**IFB # 2020-049**  
**Removal of Water Tank at Roanoke County's Explore Park**

**ADDENDUM NO. 1**

**ATTACHMENT A TO  
ADDENDUM NO. 1 TO IFB# 2020-049  
REMOVAL OF WATER TOWER AT EXPLORE PARK**

**Water Storage Tank: Elevation**

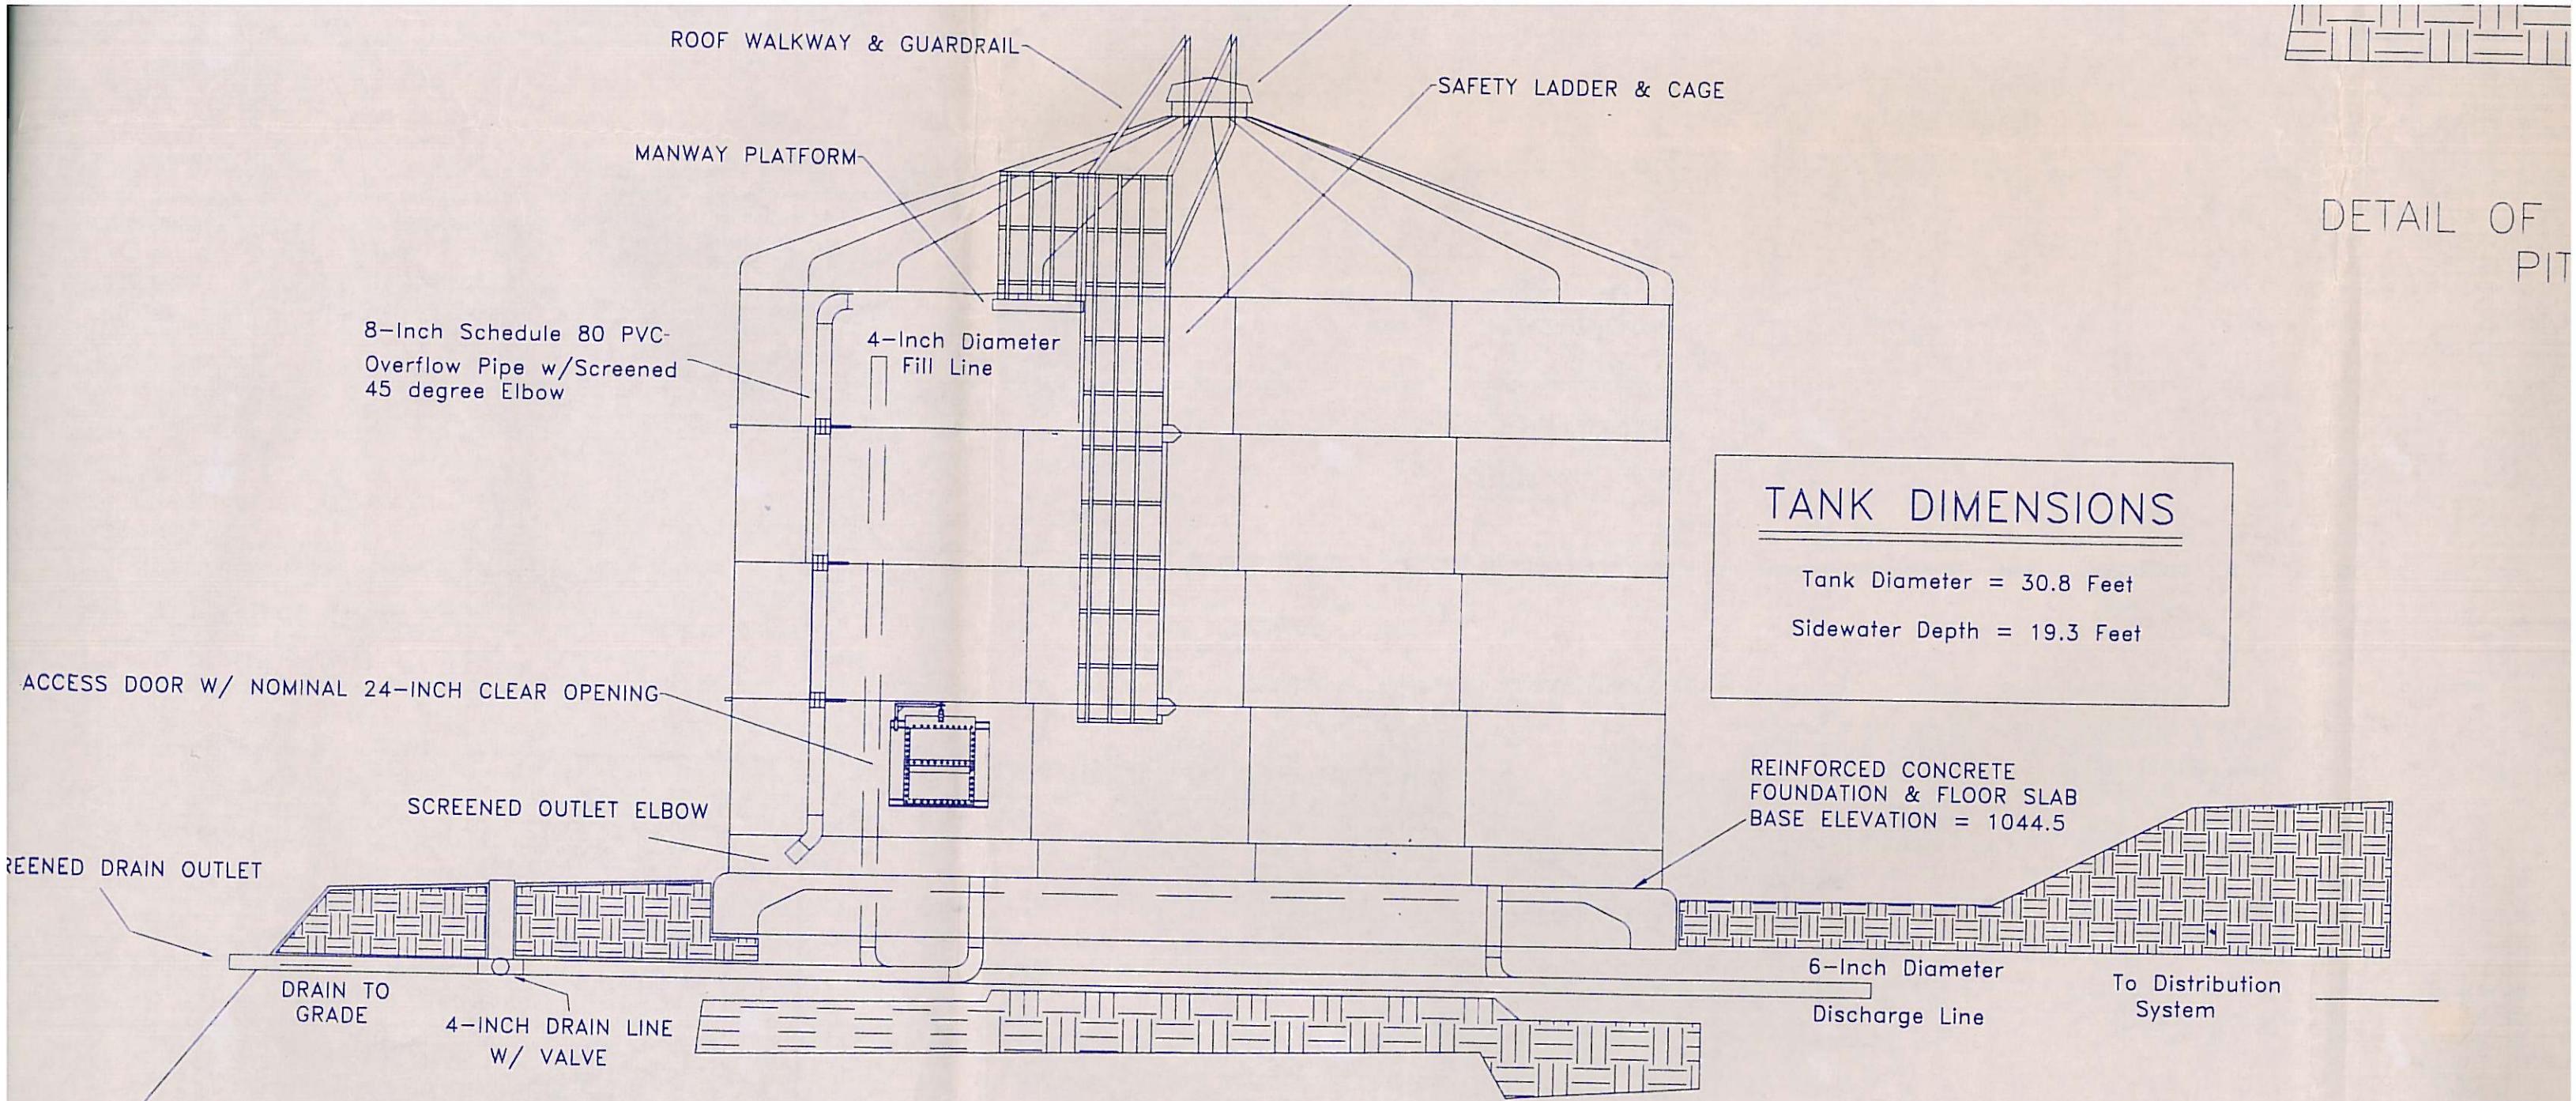
5. Are there drawings of the foundation?

9. Please provide the dimensions of the tank.

10. What is the size of the water line that needs capped?

*Please see Attachment A to Addendum 1.*

*Please see Attachment A to Addendum 1 for drawings.*

*4" inlet; 6" outlet; see drawings attached.*
